Project Address: 12 N Few Street
Application Type: Demolition Permit
Legistar File ID # [64750](#)
Prepared By: Chris Wells, Planning Division
Report includes comments from other City agencies, as noted.
Reviewed By: Kevin Firchow, AICP, Principal Planner

Requested Action: Approval of a demolition permit to allow a portion of a street-facing facade to be demolished in order for a two-story addition containing eight commercial spaces and eight apartments to be constructed at 12 N Few Street.

TITLE: 12 N. Few Street - Addition and New Construction for 8 Commercial Spaces and 8 Residential Units Located in UDD No. 8. 2nd Ald. Dist. (64038)

Image 1: Plan View of the Portion Proposed for Demolition

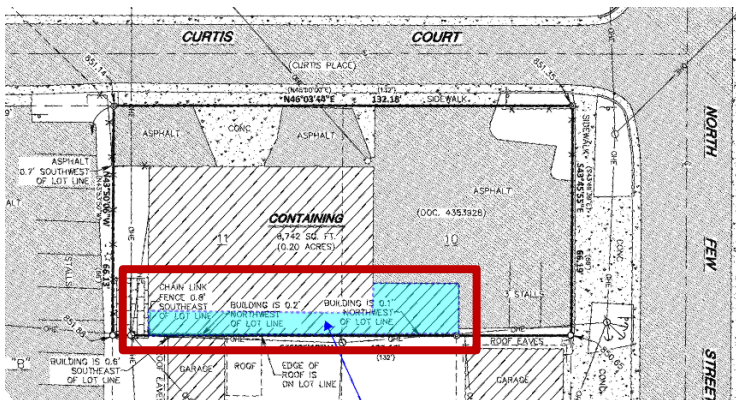
The applicant is seeking approval to demolish portions of the existing building – located on its northeastern side (i.e. facing N Few Street) and southeastern side (i.e. facing E Washington Avenue). This work includes the removal of six feet of building along the southeastern property line (to provide space for a walkway which will provide access to the residential unit entrances) and the removal of the entire, roughly 540-square-foot office ‘annex’ located off the eastern side of the building (see Images 1 and 2, below). The latter is necessary to make room for the two story addition planned on the eastern half of the site. However, because the razing of the annex will also involve razing the annex’s entire northeasterly (N Few Street) façade, this will necessitate a demolition permit review since the Zoning Code defines a demolition, in part, as “An act or process that removes, pulls down, tears down, razes, deconstructs, or destroys an existing building wall facing a public street.” These types of demolitions are referred to as *technical demolitions* by the City Zoning staff.
